SURRY POWER STATION, UNIT NO. 1

AMENDMENT TO FACILITY OPERATING LICENSE

Amendment No. 43  
License No. DPR-32

SAFETY EVALUATION BY THE OFFICE OF NUCLEAR REACTOR REGULATON

FIG 3.F.2

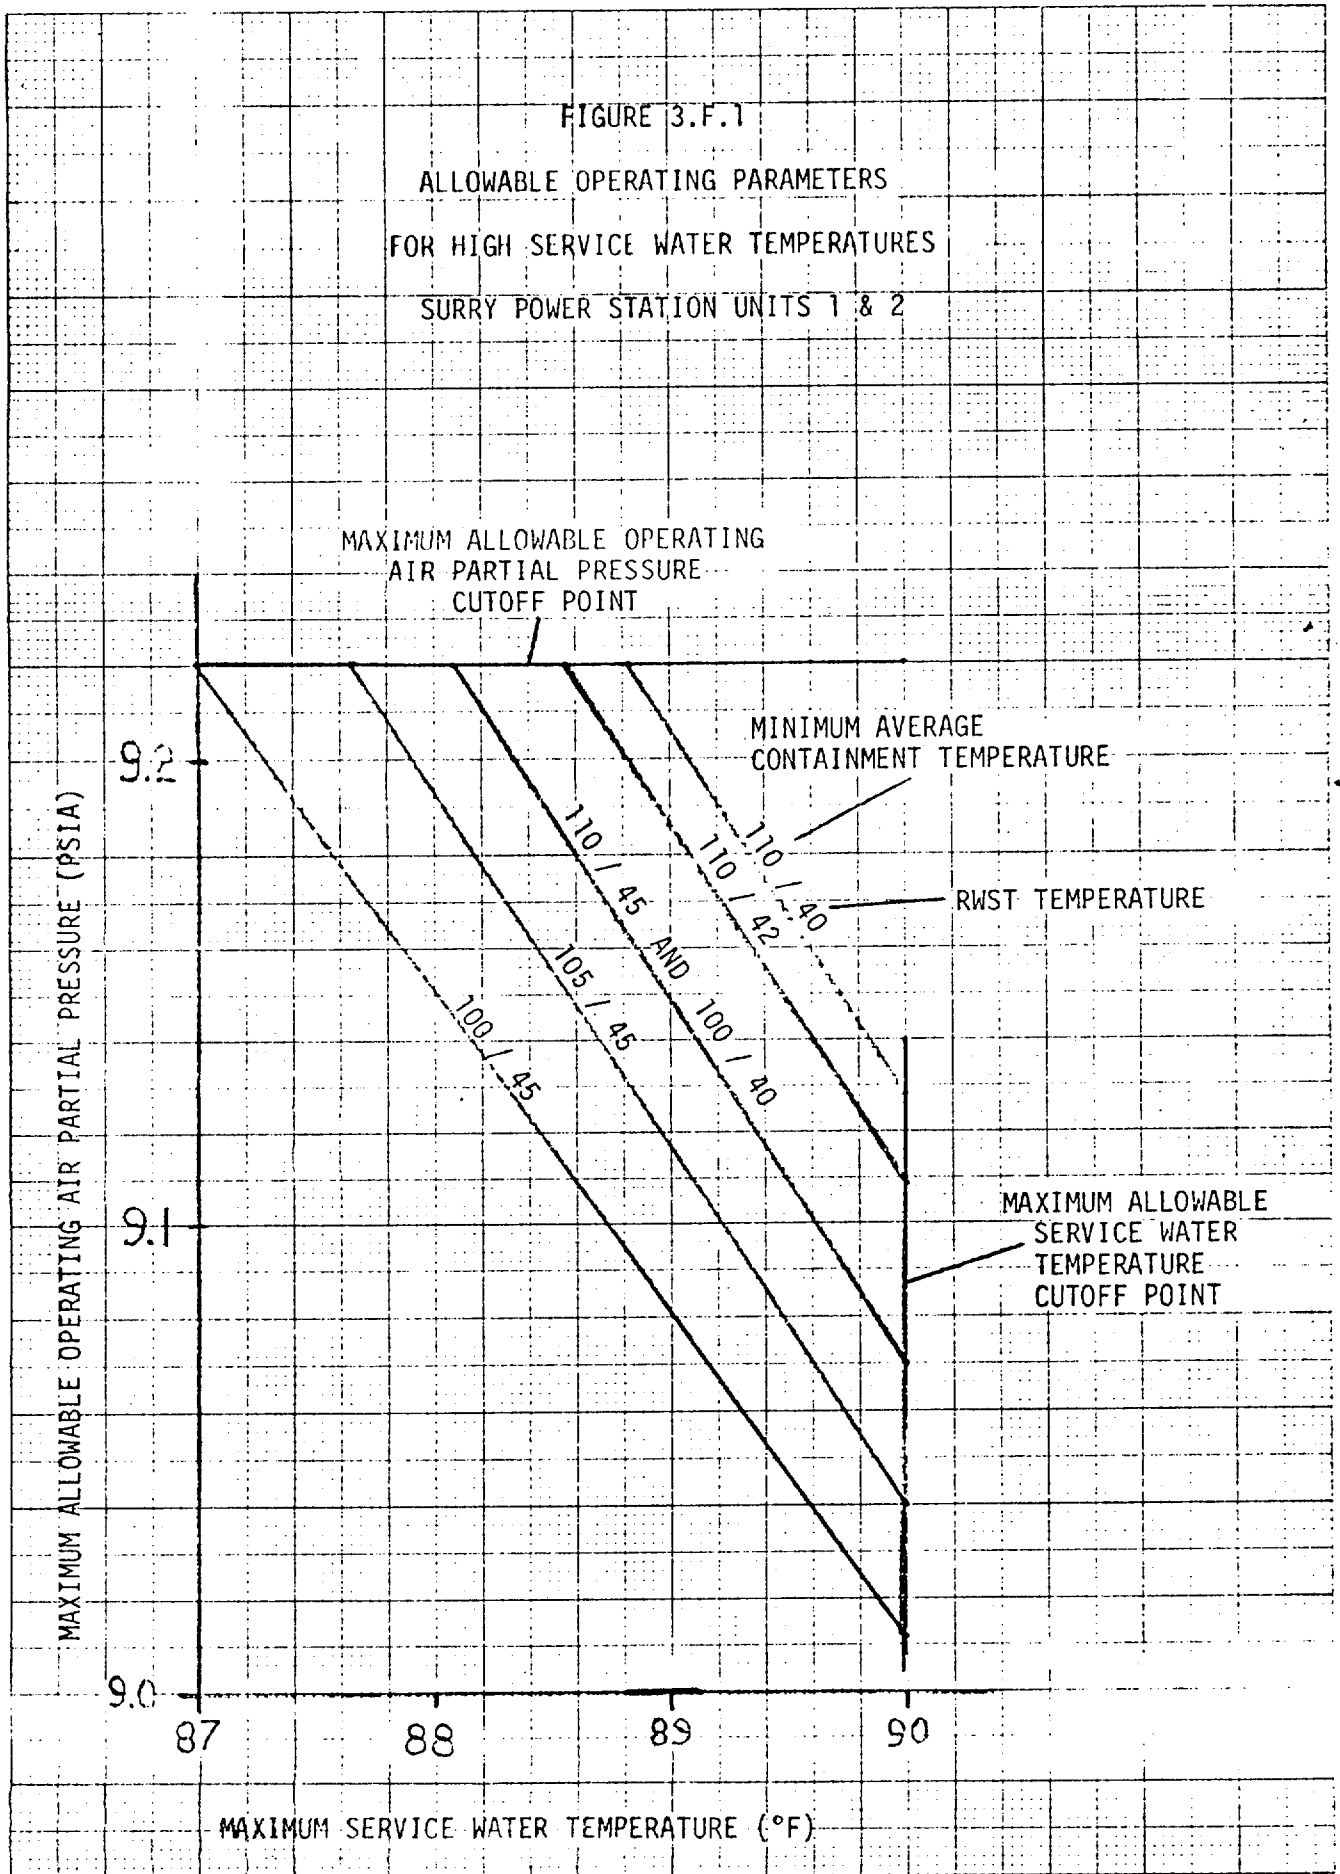
Maximum Service Water Temperature	90°F
Containment Temperature Allowable Range	100°F-125°F
Containment Air Partial Maximum Pressure	
1. For Service Water Temperature $\leq 87^\circ$	Air partial pressure shall be maintained in accordance with Figure 3.F.2
2. For Service Water Temperature $> 87^\circ$	Air partial pressure shall be maintained in accordance with Figure 3.F.1.
Minimum Refueling Water Storage Tank Volume	385,200 gallons
Outside Recirculation Spray Pump Flow Rate	2250 gpm

FIGURE 3.F.1  
ALLOWABLE OPERATING PARAMETERS  
FOR HIGH SERVICE WATER TEMPERATURES  
SURRY POWER STATION UNITS 1 & 2

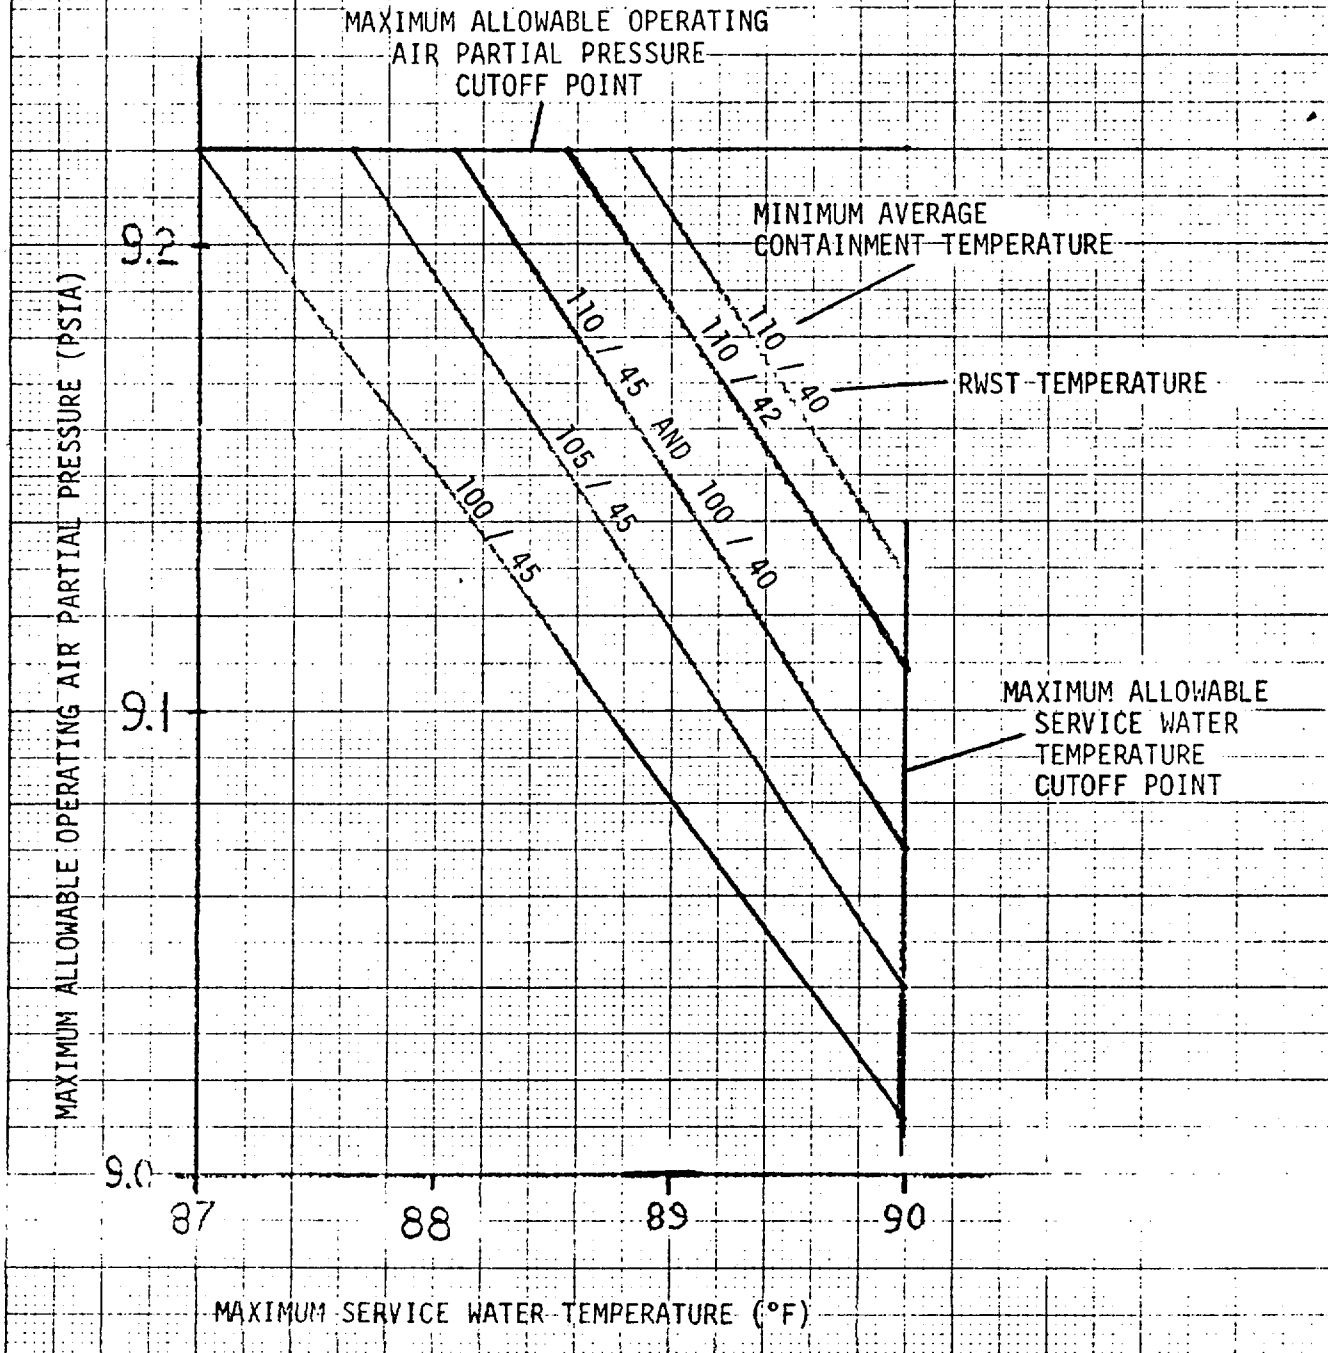
By letter dated July 25, 1978, the licensee requested that the operating limit on the service water temperature be changed from 87°F to 90°F and the limiting conditions imposed for the containment initial air partial pressures be changed in accordance with the conditions shown in the attached Figures 3.F.1 and 3.F.2. The other limits remain unchanged from those established by the Order dated June 29, 1978. The following conditions are being incorporated as a license amendment:

Maximum Service Water Temperature	90°F
Containment Temperature Allowable Range	100°F-125°F
Containment Air Partial Maximum Pressure	
1. For Service Water Temperature <u>≤</u> 87°F	Air partial pressure shall be maintained in accordance with Figure 3.F.2
2. For Service Water Temperature >87°F	Air partial pressure shall be maintained in accordance with Figure 3.F.1.
Minimum Refueling Water Storage Tank Volume	385,200 gallons
Outside Recirculation Spray Pump Flow Rate	2250 gpm

Based on our review of the results of the Stone and Webster analyses, we determined that there would be little or no effect on the peak pressure in the containment building as a result of the proposed changes. In addition to reviewing the information provided by the licensee, we have performed our own analyses using the data delineated in references 1, 2 and 3. The results of our analyses indicate that the peak containment pressure will not exceed the design pressure of 45 psig and that there will be adequate available NPSH for the pumps at the proposed conditions of 90°F.

Based on the review of the data submitted by the licensee, we find that the licensee's proposed change is acceptable. In the event that the data (e.g., mass and energy release rates, heat transfer coefficients) that is to be submitted for the permanent resolution of the NPSH issue varies significantly from the data contained in the references 1, 2 and 3, we will reexamine this matter to assure the adequacy of the available NPSH. However, we do not expect that this additional information will change our conclusions. We therefore conclude that operation of the Surry Power Station within the new limits described herein would

FIG 3.F.2

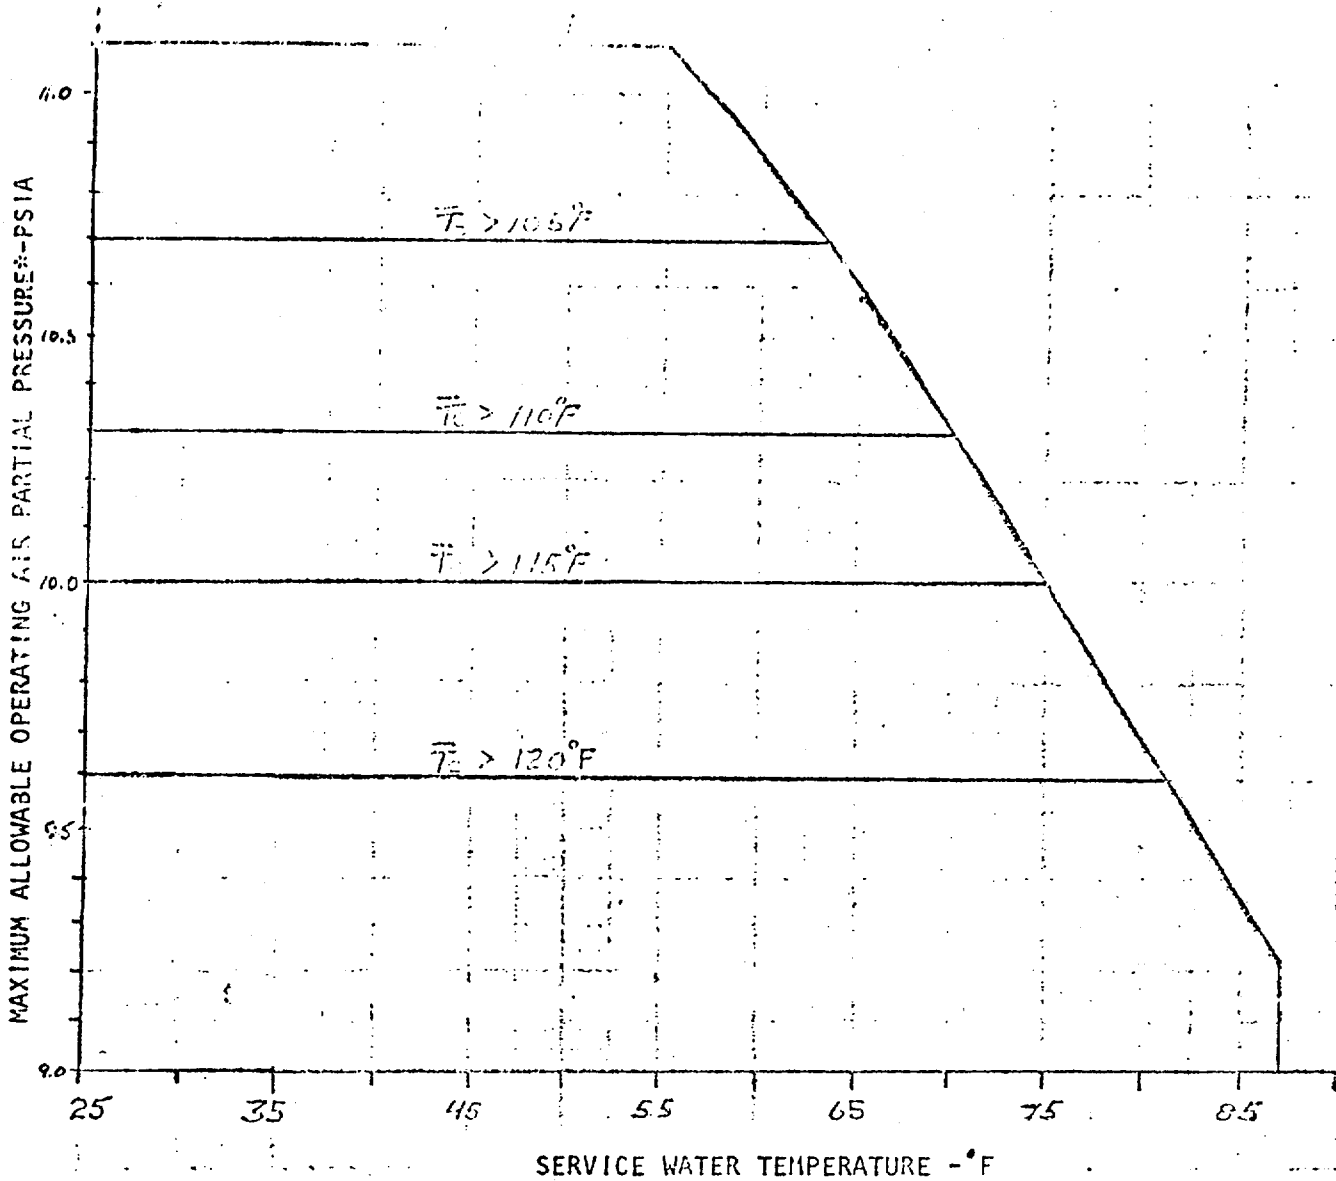
Maximum Service Water Temperature	90°F
Containment Temperature Allowable Range	100°F-125°F
Containment Air Partial Maximum Pressure	
1. For Service Water Temperature $\leq 87^\circ$	Air partial pressure shall be maintained in accordance with Figure 3.F.2
2. For Service Water Temperature $> 87^\circ$	Air partial pressure shall be maintained in accordance with Figure 3.F.1.
Minimum Refueling Water Storage Tank Volume	385,200 gallons
Outside Recirculation Spray Pump Flow Rate	2250 gpm
